Re: Site Plan Approval
9197 Highland Rd.

The following comments address the latest review letters we received, as well as, the discussion we had with your team on June 9, 2026 regarding the above addressed project that is in for Site Plan Approval. Our client is proposing to renovate the exterior of the existing 5,506 sf building that was previously approved many years ago by your community as a two tenant use with 2 drive thru's. The site as designed & constructed will remain with minor curb revisions to accommodate a new canopy on the east side of the building. The building footprint and site design shall not be altered other than the two areas indicated on our plans. Our responses below are to address and/or clarify the review comments we received. The responses below follow the reviewing agency comments numerically.

WHITE LAKE RETAIL BUILDING

PROPOSED SITE AND BUILDING IMPROVEMENTS

PROJECT -
9191 HIGHLAND RD.
WHITE LAKE, MI 48096
JOB NO.
25149-6
SHEET NO.
AS-1

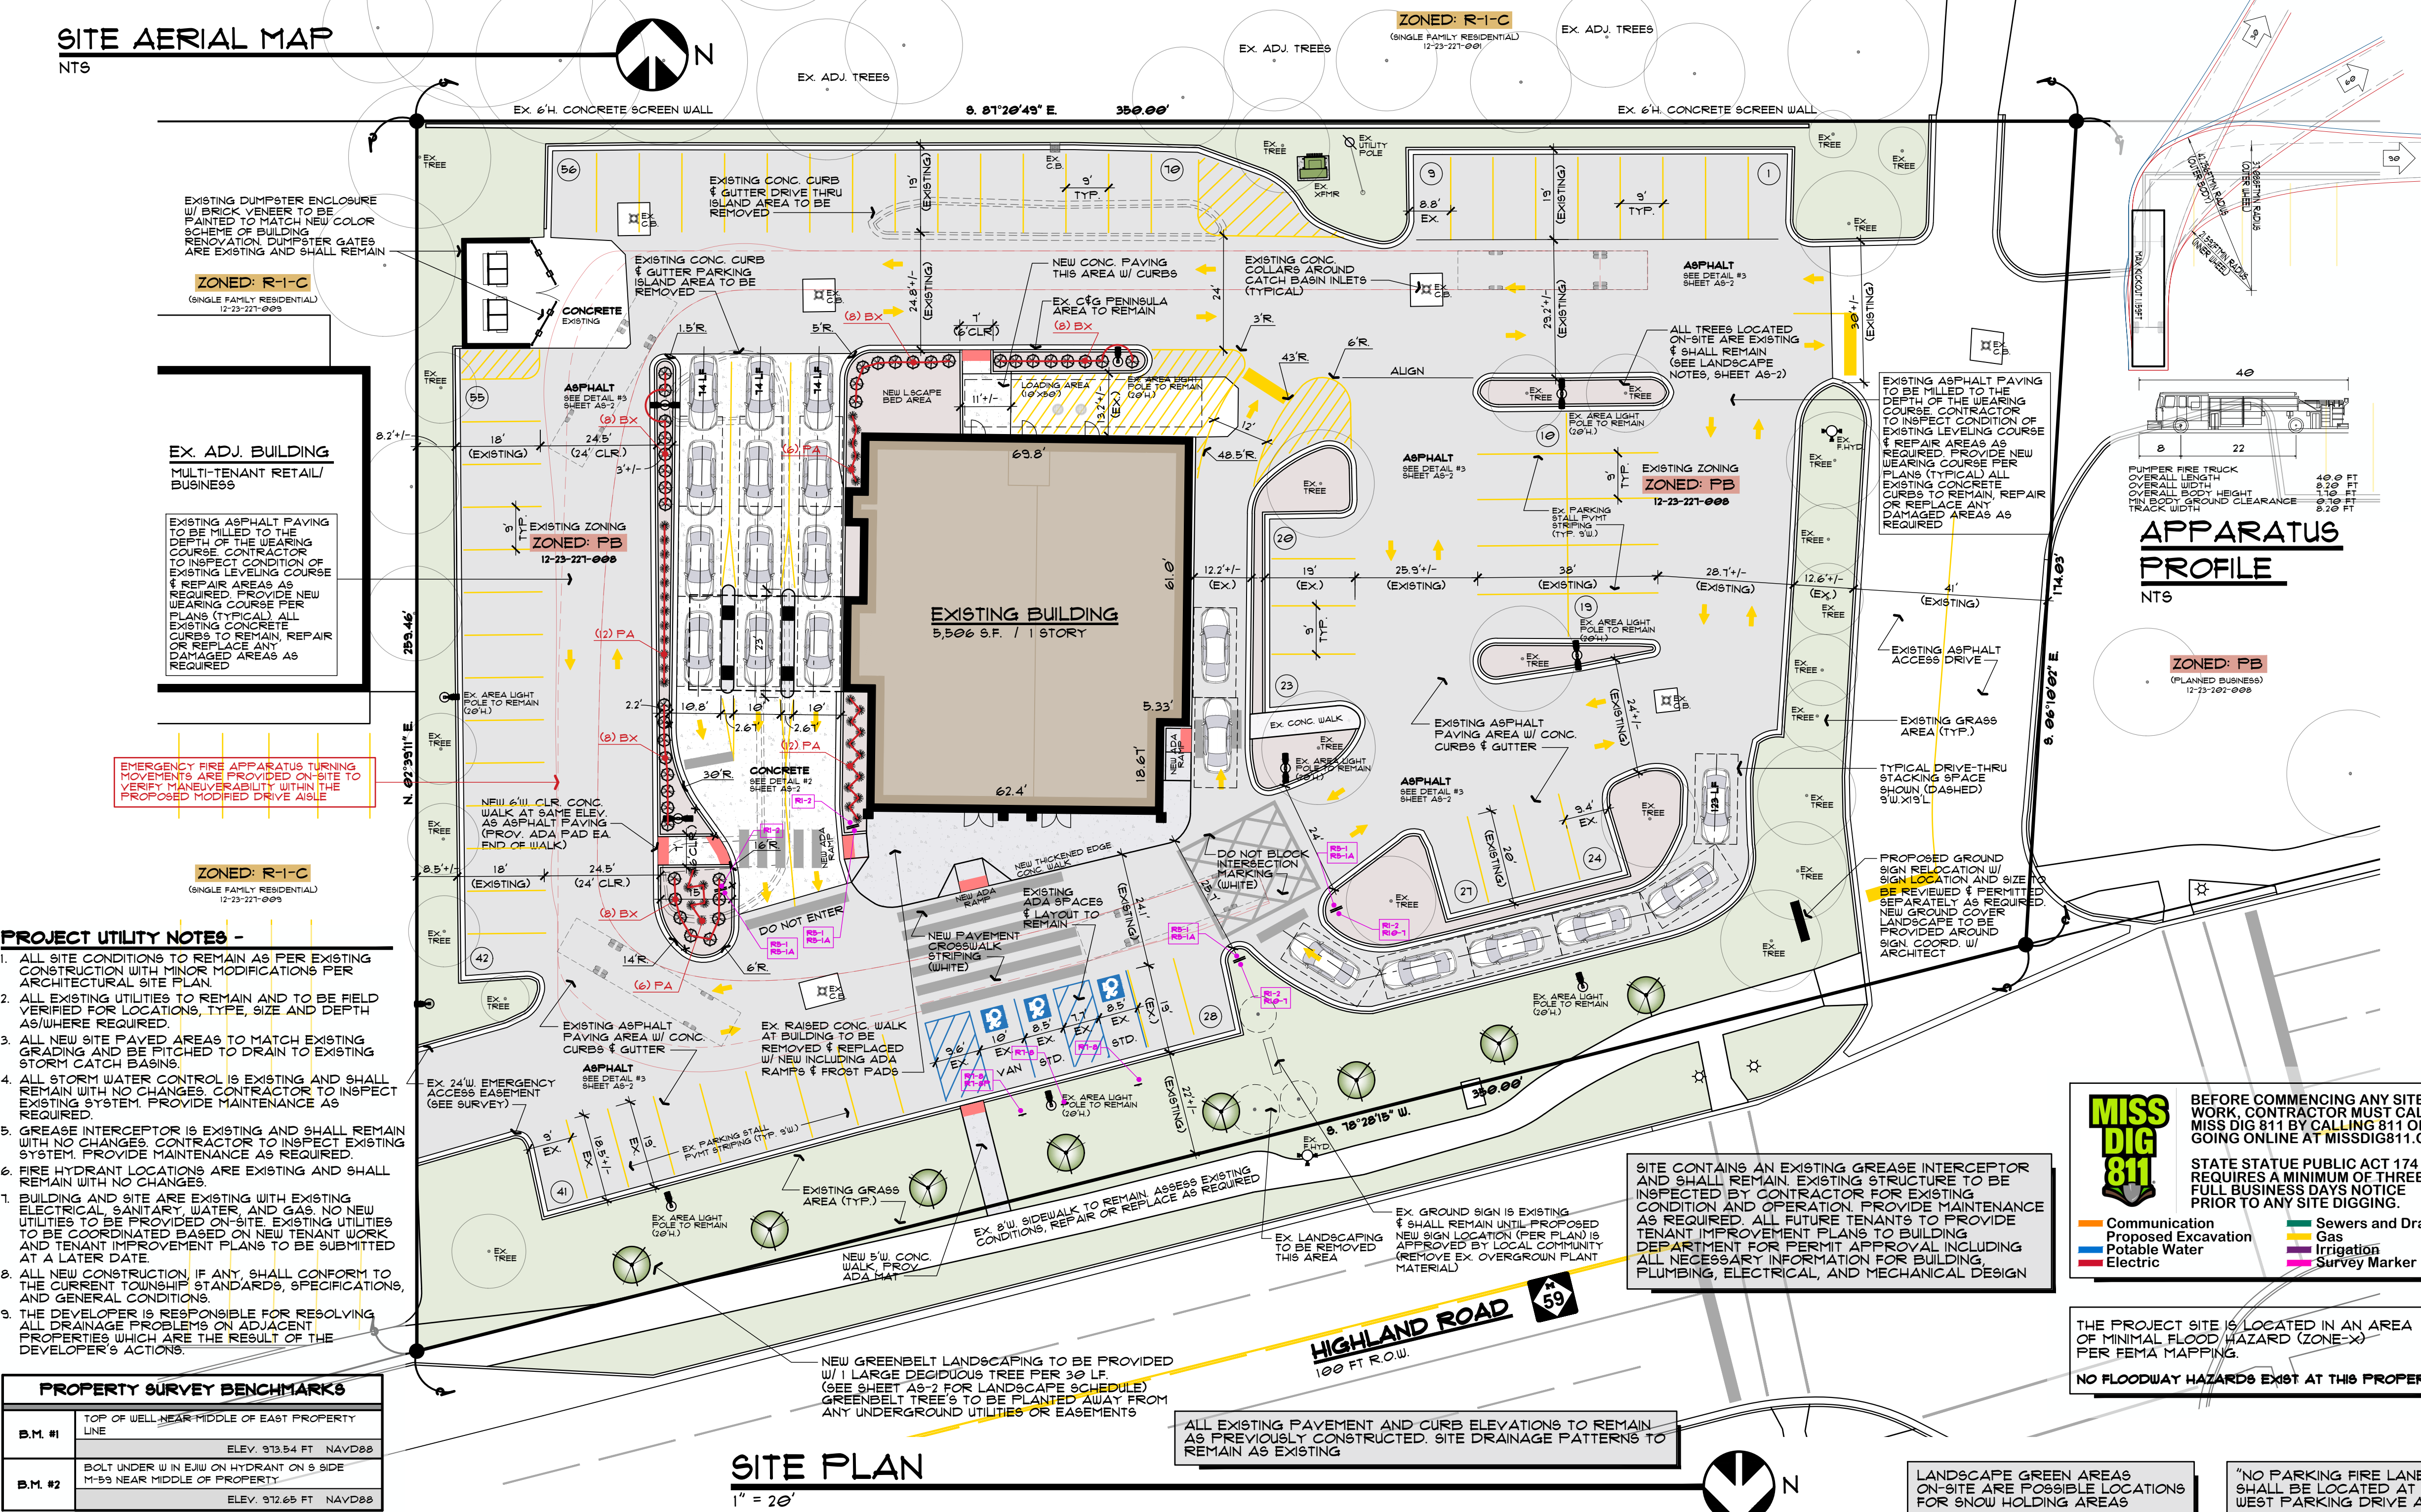
7. There are no proposed changes to the drive, however no dimensions or distances.....
The dimensions between the existing adjacent approaches are shown on Sheet AS-1 Site Aerial Plan for reference.

8. Stacking space dimensions should be added to the site plan to ensure compliance.
Our plan shows cars in the existing & revised drive-thru lane for identifications purposes. We have shown dimensions for reference on Sheet AS-1.

1. The required turning radius shall accommodate the largest Fire Department apparatus.....
There are no changes to this existing as built site that was previously approved that would limit or prohibit any emergency vehicle circulation. The tracking is shown on our Site Plan Sheet AS-1.

1. Sheet AS-1 shall be sealed by a licensed Michigan design professional.
The hard copy plans provided are sealed. (Electronic plans are not sealed).
2. Sheet 1 ALTA/NSPS Land Title Survey- Survey shall be sealed and signed by a PS.....
No Comment Needed / The ALTA Survey has been sealed and signed.

4. Sheet AS-1- Legal Description of record references incorrect parcel ID# and parcel address.....
No Comment Needed / Sheet AS-1 has been revised as noted.

1. Provide a fire truck turning plan for a standard 40 foot long fire truck.
This has been shown on our Sheet AS-1
2. Sheet AS-1- Provide length dimension for drive-thru stacking space on this plan sheet.
Stacking is already shown on the plan (AS-1) with added dimensions.

3. Sheet AS-1- Provide dimensions for ADA spaces and associated loading zones.
The information is already indicated on the plans. The Loading Area is shown and noted on Sheet AS-1 and the ADA Parking Space information, dimensions, notes and details are clearly indicated on Sheet AS-1 & AS-2 Detail 5. The dimensions exceed required minimums.

4. Sheet AS-1- We recommend that the crosswalk striped area adjacent to the proposed ADA.....
*This area **will not be** marked with "No Vehicular Traffic" signage. This is the main drive aisle and circulation for the site and will remain as originally approved & constructed for the prior development. The suggested change would prohibit cars from entering the area to even park in the ADA spaces. This **is not** a functional or practical recommendation.*

5. Sheet AS-1- Northernmost parking area – Space length measures to 18.5' B/C (NE area).....
This is an existing approved and already constructed site that will remain unchanged per our plan information. The parking spaces referenced are all existing and shall remain dimensionally as presently indicated on the Site Plan. All dimensions are shown on the plan which meet the ordinance. All comments are based on the information we have.

6. Sheet AS-1- The two-way drive just NE of the "Do Not Block" intersection marking appears.....
This is an existing approved and already constructed site that will remain unchanged. Per the information we have regarding the site all dimensions are correct as noted on the plans.

7. The condition of the existing sidewalk along the M-59 frontage shall be assessed for any.....
No Comment Needed / An additional note has been added to our Site Plan Sheet AS-1 regarding this comment.
8. The condition of the existing onsite curbing and pavement shall be assessed; any portions.....
No Comment Needed / Our plan already clearly notes the existing asphalt to be milled. We have added a note to inspect all concrete curbing and repair or replace as needed.
